UNITED STATES PATENT AND TRADEMARK OFFICE

APPLICATION NO.	FILING DATE	FIRST NAMED INVENTOR	ATTORNEY DOCKET NO.	CONFIRMATION NO.
10/041,705	01/08/2002	James Arthur Peterson	2992.02US02	5457

Office Action Summary

DETAILED ACTION

FIG. 1FIG. 2FIG. 3FIG. 4

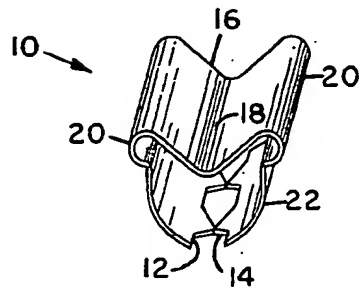
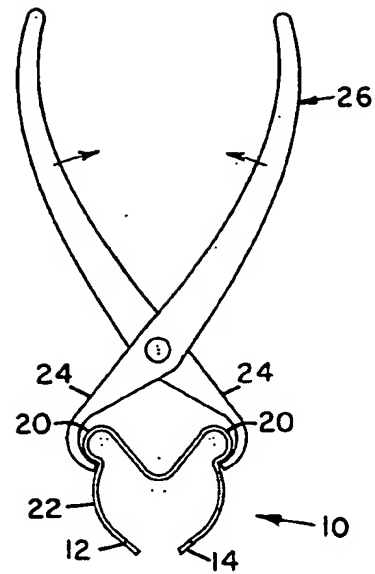
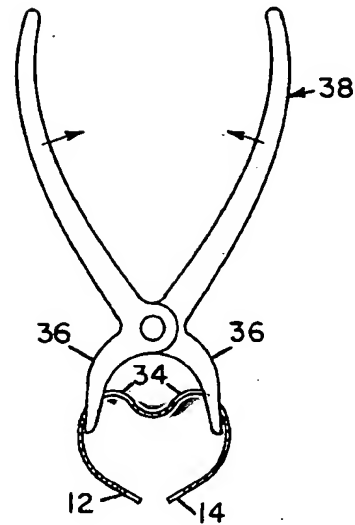
These apertures (along with the edges of the aperture) can be called expansion engagement structures, and are located proximally to the junction of the bending beam (20/32/20) and the constraint segments (22 and 22), as explained pictorially in Attachment #1.

bending beam
shown blue

constraint
segments
colored
yellow
